### APPEAL SUMMARY

<b>Appeal ID:</b> 23398	<b>Project Address:</b> 7000 NE Airport Way
<b>Hearing Date:</b> 2/5/20	<b>Appellant Name:</b> Leslee Randolph
<b>Case No.:</b> B-002	<b>Appellant Phone:</b> 5039735151
<b>Appeal Type:</b> Building	<b>Plans Examiner/Inspector:</b> Jeff Donnelly
<b>Project Type:</b> commercial	<b>Stories:</b> 3 <b>Occupancy:</b> A-3, A-2, M <b>Construction Type:</b> I-A
<b>Building/Business Name:</b> Port of Portland_PDX	<b>Fire Sprinklers:</b> Yes - Restrooms within Terminals
<b>Appeal Involves:</b> Reconsideration of appeal	<b>LUR or Permit Application No.:</b> 18-260999-FA
<b>Plan Submitted Option:</b> pdf [File 1] [File 2] [File 3] [File 4] [File 5] [File 6] [File 7] [File 8]	<b>Proposed use:</b> Airport Terminal

**Use of 2017 ICC A117.1 standard for ambulatory toilet compartment in lieu of 2009 standard: Granted as proposed.**

PORTLAND INTERNATIONAL AIRPORT				
TERMINAL RESTROOM MODERNIZATION 2018 SYMBOLS, ABBREVIATIONS, CODE SUMMARY				
SUBMITTED BY TOM WHARTON PROJECT ENGINEER	TYPE CD	DRAWING NO. PDX 2018-514	SHEET NO. 4/112	DISC. SHT. NO. A0.01

FIGURE 604.10.1  
AMBULATORY COMPARTMENT

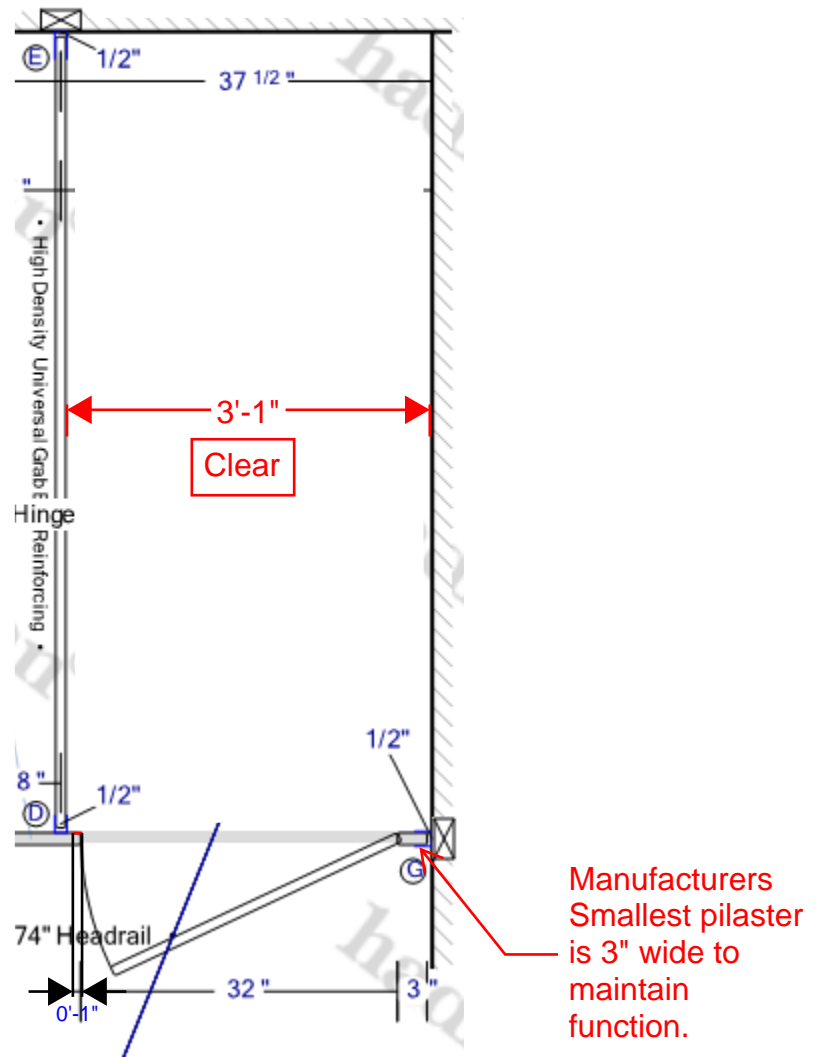
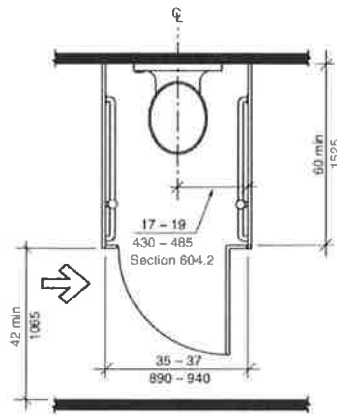
**Reason for alternative** Standard toilet partition components cannot achieve clear width of 36 inches while maintaining a clear width of Doors and Doorways of 32 inches per ICC A117.1-2009 and ICC A117.1-2017 404.2.2. This can be achieved at ambulatory stalls with standard toilet partition components at a maximum of 37 inches in width. This design meets the intent of the updated ambulatory stall requirements per of ICC A117.1-2017 604.10.2 Size (See below for diagram) that the OSSC 2014 1101.2 Design ICC A117.1-2009 604.10.2 Size has not adopted yet.

Per ICC A117.1-2009 and ICC A117.1-2017 404.2.2 Clear Width Doorways shall have a clear opening width of 32 inches minimum. Clear Opening width of doorways with swinging doors shall be measured between the face of door and stop, with the door open 90-degrees. This means no latches or hardware may project into this clear 32 inch required opening. Standard toilet partition component door stops project into the clear opening 1 inch. The thickness of the standard toilet partitions of 1/2 inch, 1 inch door stop, 32 inches clear opening, 3 inch pilaster (the smallest the manufacturer can make to maintain function of the door) and 1/2 inch wall or u bracket equals 37 inches installed. Standard toilet partition components cannot achieve clear width of 36 inches while maintaining a clear width of Doors and Doorways of 32 inches per ICC A117.1-2009 and ICC A117.1-2017 404.2.2. See attached ambulatory partition plan example.

The clear doorway width of 32 inches and ambulatory stall requirements of 36 inches clear cannot be achieved with standard toilet partition components. The clear widths can be achieved at ambulatory stalls with standard toilet partition components at a maximum of 37 inches in width. This design meets the intent of the updated ambulatory stall requirements per of ICC A117.1-2017 604.10.2 Size see attached for the diagram, that the OSSC 2014 1101.2 Design ICC A117.1-2009 604.10.2 Size has not adopted yet.

1/2" partition width + 1" door stop + 32" clear opening + 3" pilaster + 1/2" wall bracket = 37"
